BECKER, LLC. (Wawa Convenience Store and Fuel Service Station)
Special Exception Use Application
P22-006

Applicant's Request:	The request is for approval of a Special Exception Use (SEU) for a Wawa convenience store with a fuel service station.
Applicant's Agent:	Brad Curry, Engineering, Design, and Construction, (EDC)
Applicant/Property Owner:	Becker, LLC.
Location:	Located at the southwest corner of SW Port St. Lucie Boulevard and SW Becker Road.
Address:	TBD
Project Planner:	Holly F. Price, AICP, Senior Planner

Figure 3. Conceptual Site Plan

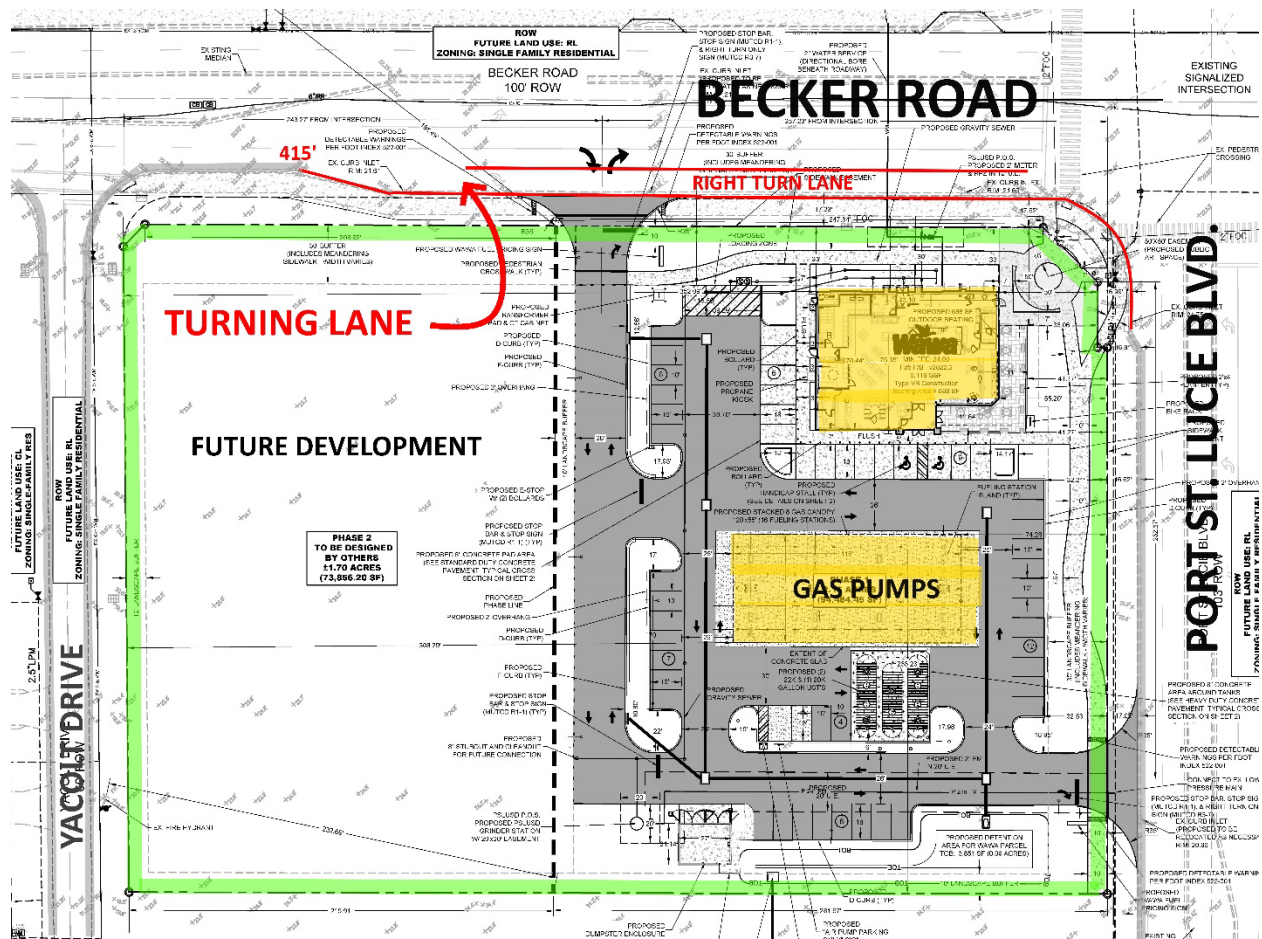
P22-198 Wawa Variance: On August 2, 2022, the Planning and Zoning Board voted unanimously to grant a variance to allow a proposed mid-block driveway to be located in the right-turn lane on Becker Road. See Figure 3. below. Public Works opposed the variance application.

This property is located at a major intersection of two arterial roads on the south side of the city. The property is currently one parcel. The proposed Wawa is located on the east (right) side of the property. See Figure 3. The block length along Becker Road is 498 feet and the distance to the proposed driveway is approximately 257 feet from Becker Road and 243 feet from Yacolt Drive. The driveway does not meet minimum spacing distance. The minimum driveway spacing requirement is 250 feet. More importantly, the proposed driveway is also located in the functional area of the intersection creating a safety concern due to the additional traffic conflict point it creates.

- Staff findings: The project as proposed does not meet these criteria. Ingress and egress on Becker Road is not satisfactory. The Public Works Department has indicated that they do not support the proposed mid-block driveway from Becker Road since the driveway would extend from a southbound turn lane – and be located in the functional area of influence near the intersection of Becker Road and Port St. Lucie Boulevard. The southbound turning lane extends approximately 415 feet from Port St. Lucie Boulevard, or almost the entire length of the block. See Figure 3. The proposed driveway would extend from the turning lane. A driveway in this area would cause conflict between drivers wanting to turn right at the corner and drivers wanting to turn right into the property. It should be noted that Public Works does not object to the proposed land use, Public Works just does not support the proposed driveway location due to safety concerns.

- Per City Code Section 158.222(B)(4), the driveway spacing from intersections shall be measured from the right-of-way line of the intersecting street to the midpoint of the driveway. The minimum spacing shall be 250' for a commercial site on Becker Road. However, the applicant is proposing a driveway separation distance of 243'. Of more concern to the Public Works Department, the proposed driveway is being proposed within the existing right turn lane of the Becker Road and Port St. Lucie Blvd. intersection. City Code goes on to state that *"standards in excess of these spacing requirements are preferable and may be required for driveways located within the functional area of an intersection or areas where access restrictions are necessary to reduce conflicts, preserve the safety of the traveling public, or to preserve the function of the adjacent roadway."*; such as with this particular case to reduce conflicts.

- South Side: The south side has a 10-foot-wide landscape buffer. However, the south of the site side features a gas station canopy, fuel pumps, and parking that would not be screened adequately from view if the hedge is two feet in height as required by code or if palm trees are used, as currently proposed. The fueling station cars, pumps, and canopy would be visible to the neighbors to the south. **Staff recommends that the applicant provide a 6-foot-high opaque fence in the landscape buffer** to provide a visual screen for the neighbors to the south. In addition, the type of proposed trees should include canopy trees such as oak trees, not palm trees, that will facilitate in creating an opaque landscape buffer. If the entire parcel, inclusive of Phase 2 is cleared, the landscape buffer on the south side should be continued along the entire south side of the property. Otherwise, residents to the south will have view of Becker Road.

- **Staff findings: The project as proposed does not meet these criteria in terms of vehicular movement.** The Public Works Department is not in support of the proposed access driveway that extends from a right-turn lane on Becker Road. See comments in Paragraph A. The proposed vehicular movement is not supported by Public Works. As currently proposed, there would be an increase in the likelihood of additional thru-traffic within the surrounding neighborhood.

1) Becker Road Mid-block Driveway Access: Staff finds the requirements of Zoning Code Section 158.224, Driveway Spacing from Intersections, to insure public safety and high-quality public infrastructure have not been met and staff finds that there are viable alternatives that would not create a potentially hazardous driveway configuration at this location. The proposed mid-block access driveway located on Becker Road shall be eliminated. The Conceptual Site Plan shall be updated prior to SEU approval by the City Council.

3) Buffering on South Perimeter Lot: The Conceptual Site Plan and/or Landscape Plan shall be modified prior to SEU approval by the City Council to indicate either a 6-foot-high opaque fence in the landscape buffer. In addition, the type of proposed trees shall include canopy trees such as oak trees, not palm trees, and other vegetation that will facilitate in creating an opaque landscape buffer. If the entire parcel, inclusive of Phase 2 is cleared, the landscape buffer on the south side shall be continued along the entire south side.

Public Works recommends moving the driveway location from Becker Road to SW Yacolt Drive. By providing a right turn lane on Becker Road to SW Yacolt Drive and then blocking off SW Yacolt Drive south of this Wawa Property entrance, the driveway will meet all required Engineering Standards for spacing and safety. By blocking off SW Yacolt Drive, this will also prevent all cut through traffic that could occur from Port St. Lucie Blvd and Abraham Avenue, therefore reducing any unnecessary nuisance to the surrounding neighborhood.
